Downtown Subarea Plan Proposed Amendments Update Sheet:

The Downtown Subarea Plan can be seen: <http://www.ci.bremerton.wa.us/371/Downtown> or at the City of Bremerton website: www.ci.bremerton.wa.us: Home-Our Government-Community Development-Downtown. The following are proposed amendments to the Comprehensive Plan and development regulation portions of the Downtown Subarea Plan.

1.1 SUB AREA PLAN GOALS

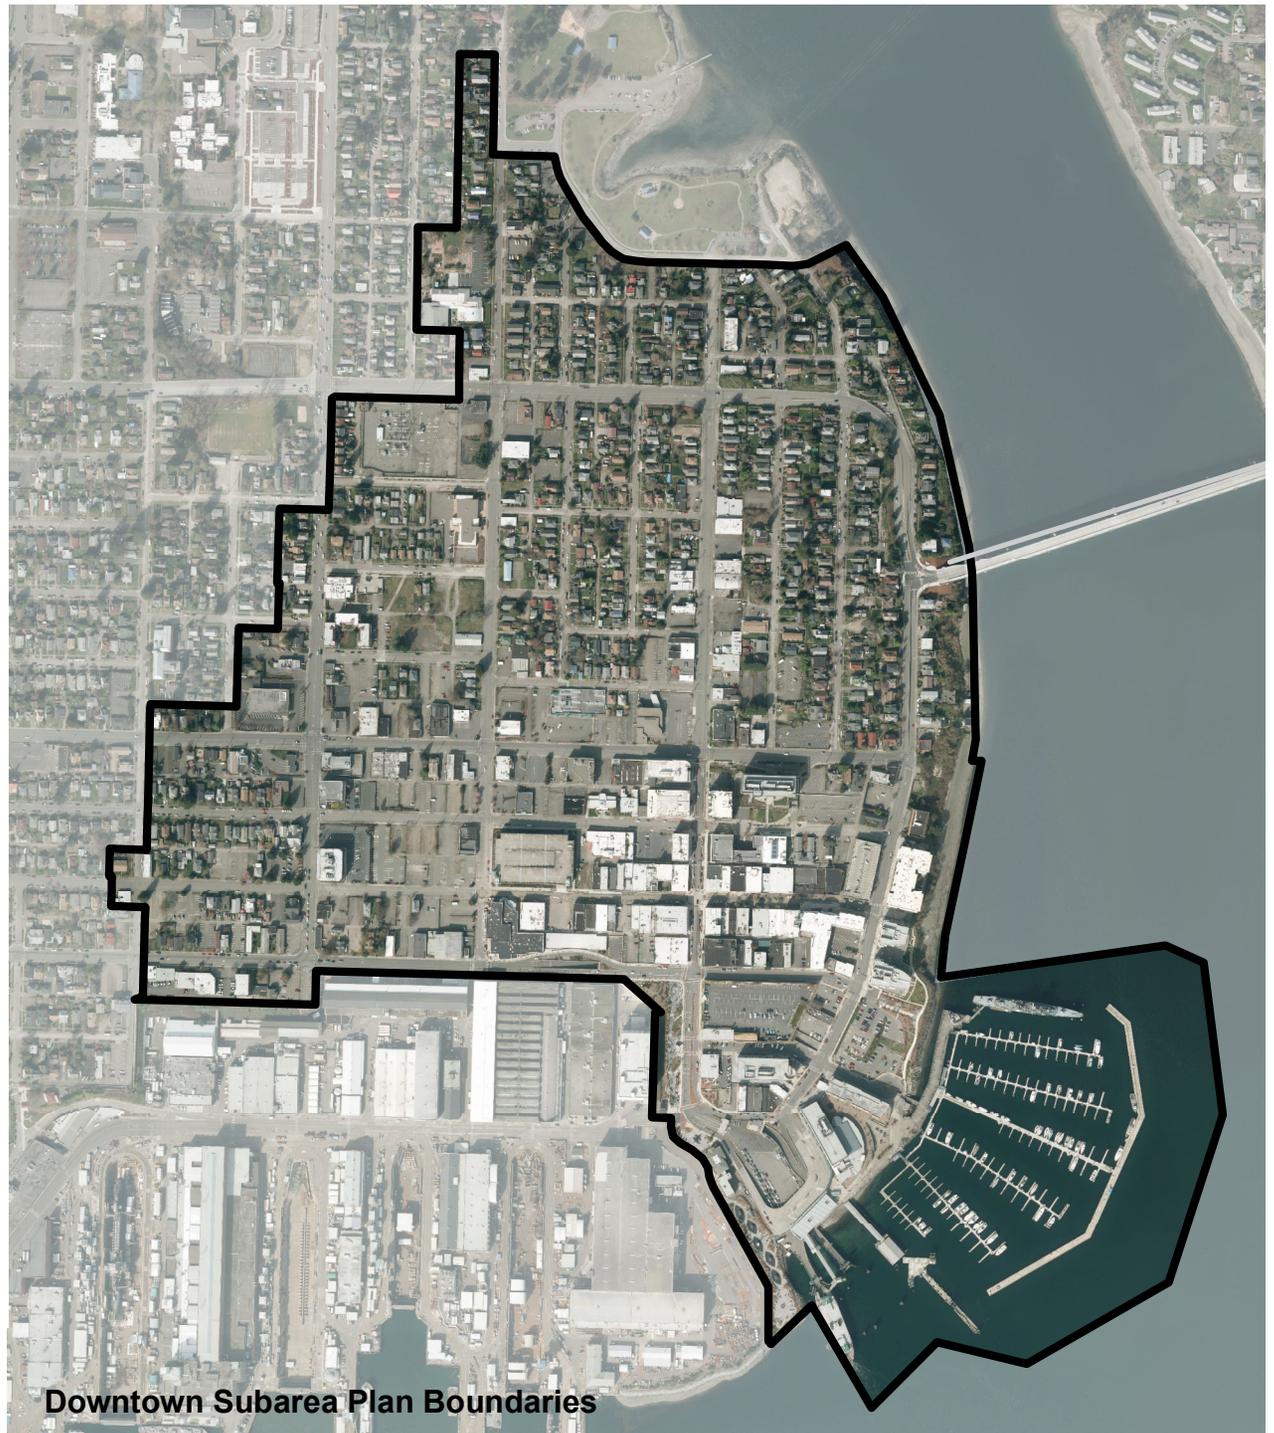
Page	Title or Figure for Proposed Revisions	Proposed Revisions to the Comprehensive Plan Portion	Other Information
Introduction: page I-5	1.0 Introduction, Purpose and Need; second paragraph	Revise second paragraph to reference 2016 Comprehensive Plan Update: "The Sub Area Plan supports and implements the policies presented in the 2004 <u>and the updated 2016</u> City of Bremerton Comprehensive Plan..."	Updated to be current with Comprehensive Plan Update.
Introduction: page I-5	Downtown Subarea Study Area Boundaries Map	Revise map to provide additional area that was identified in the Comprehensive Plan Update.	This includes the area west of Warren Avenue between Burwell and 6 th Streets. Replacement page has been included as Exhibit 1 .

5.4 STREET TYPOLOGIES

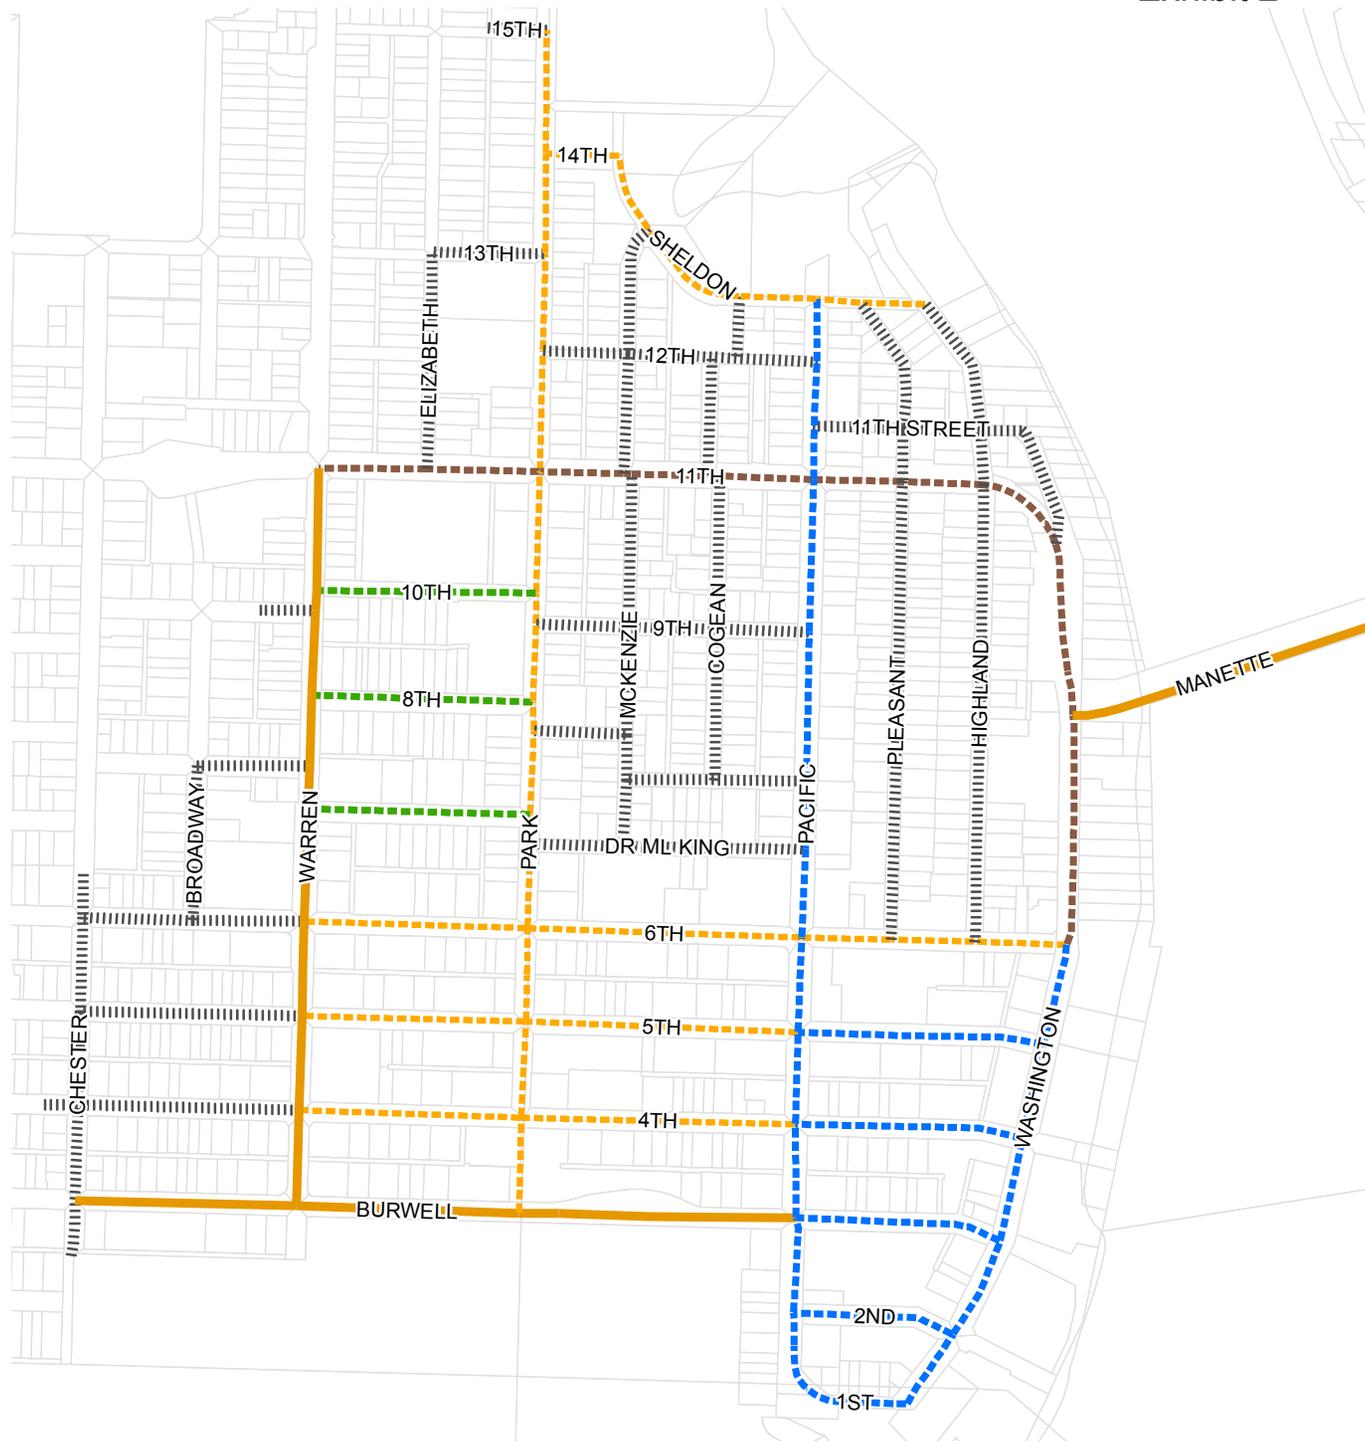
Page	Title or Figure for Proposed Revisions	Proposed Revisions to the Development Standards Portion	Other Information
Circulation: page 5-70	5.4 Street Typologies Map	(a) Revised map to include the street from the Center expansion proposed in the Comprehensive Plan Update. Street Typologies should be the following: Burwell Avenue is a Regional Arterial typology; and 4 th Street, 5 th Street, 6 th Street, Chester Avenue, and Broadway Avenue are proposed as Residential Streets. (b) Include the following provision at the beginning of Street Typologies: <u>In following sections of descriptions of street typologies, existing right-of-ways that do not meet the identified width for all improvements will be required to coordinate with Department Public Works and Utilities on appropriate streetscapes.</u>	Replace page with revised map – it has been included as Exhibit 2 . (b) This was an issue for a project that had an existing right of way that was 40' yet, the improvements required 60'. This provision will allow Staff to work within the Code.
